EA Project No.: 16-1100

DATE OF ISSUANCE: February 14, 2017

Notice: This addendum is issued to all prospective bidders as an amendment to the Drawings and Project Manual for the Canopy Row. Bidders shall acknowledge this addendum on the Bid Form. All information contained herein shall be fully incorporated into the Contract Documents as though originally included therein.

M202

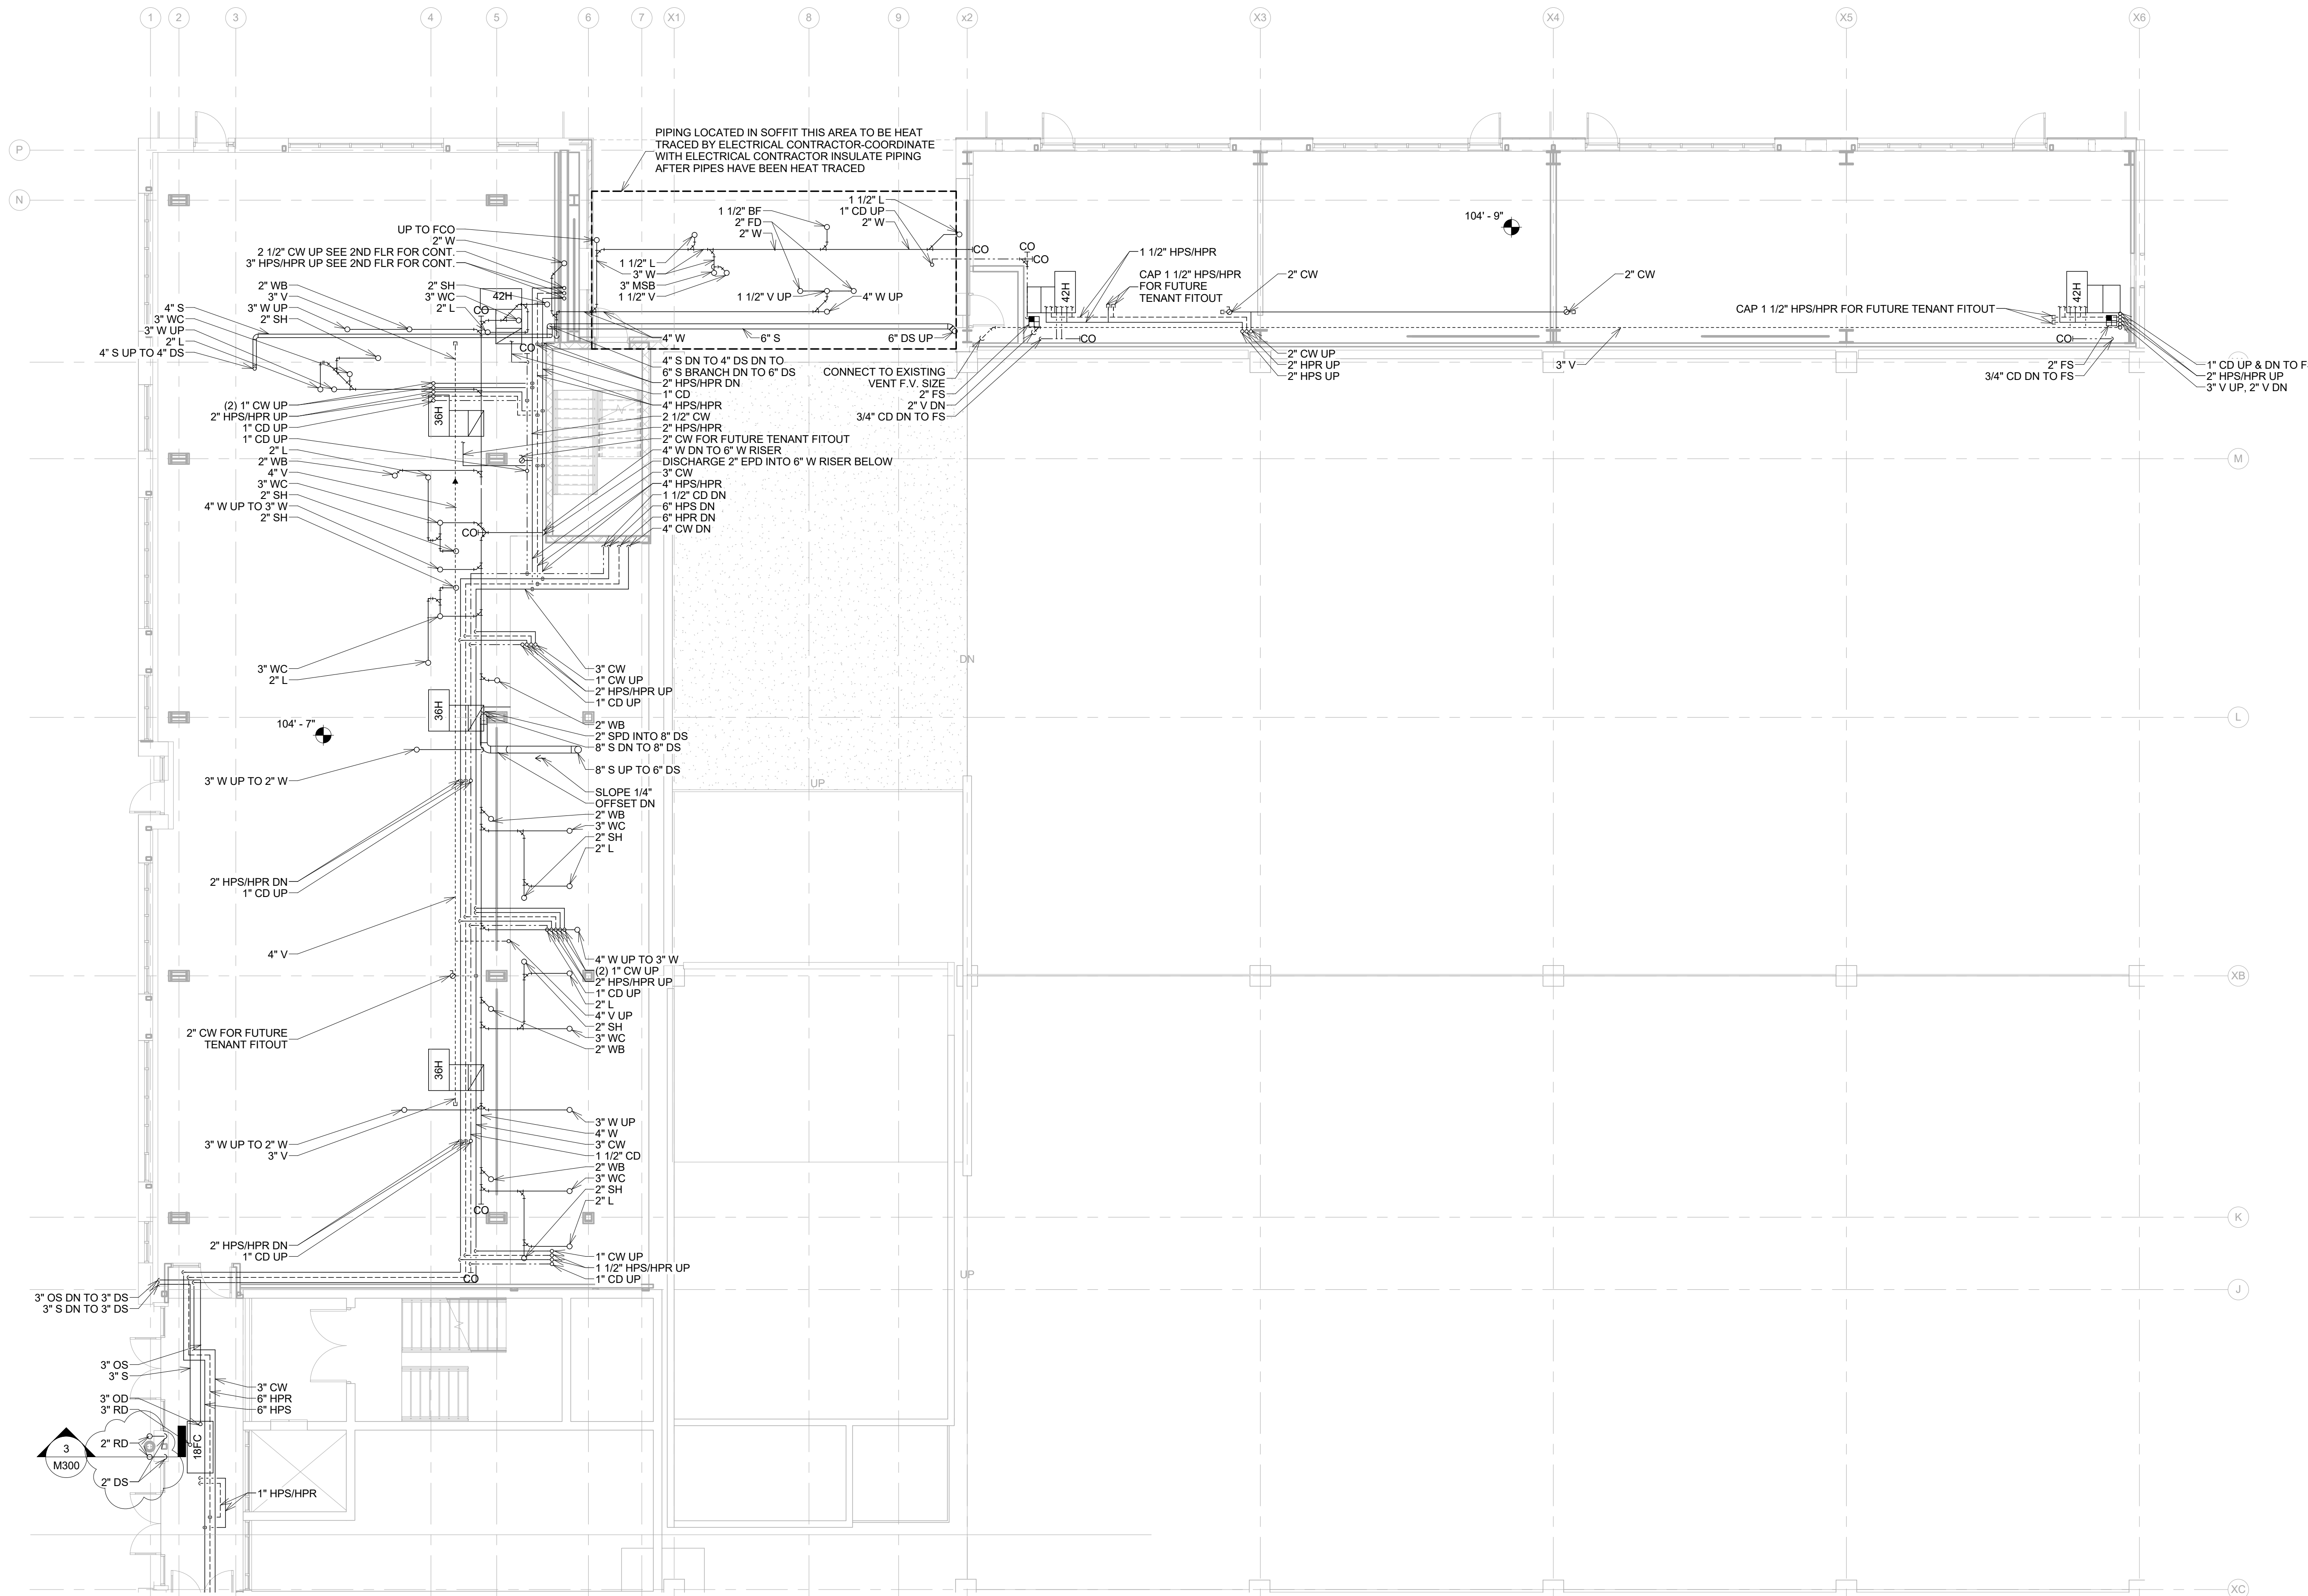
Reference Revised Sheet M202

Add two 2" DS for the roof drain in the canopy over Vestibule 101 entrance tying into 3" under floor storm.

Revise the under floor waste in building so that existing garage 4" waste is to be removed and replaced with a 4" waste pipe inside 6" PVC sleeve and the 4" waste from the building C first floor tenants to tie into the 4" garage waste pipe downstream of the double grade cleanout outside the building.

M212

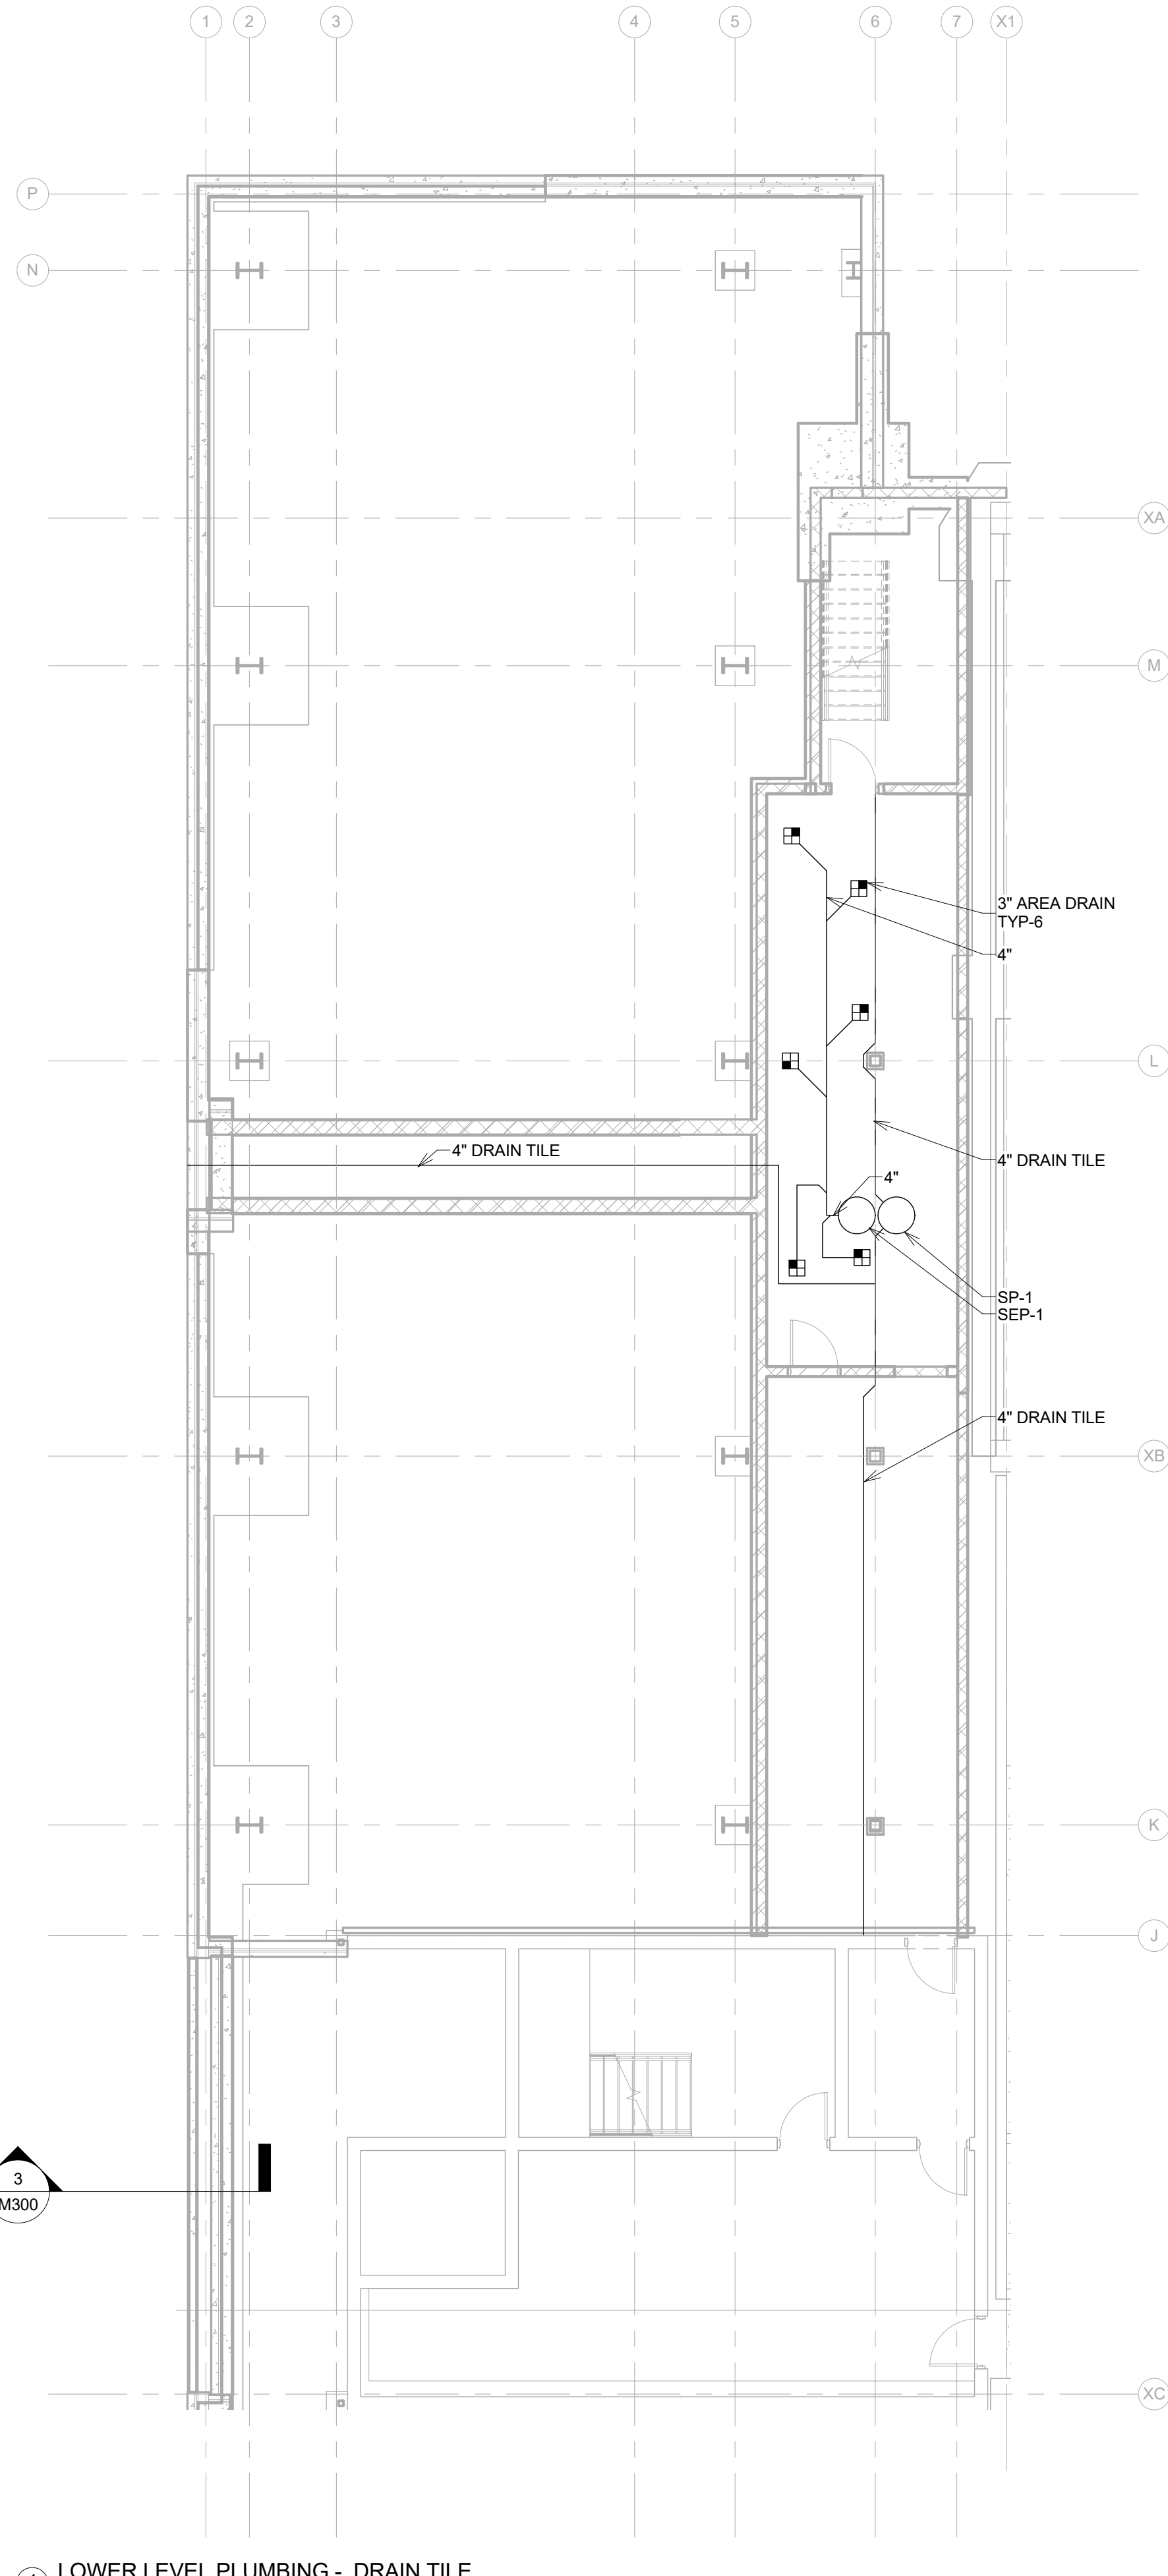
Reference Revised Sheet M212

Add two 2" roof drains in the canopy over Vestibule 101 entrance and drop to the 3" under floor storm with two 2" downspouts.
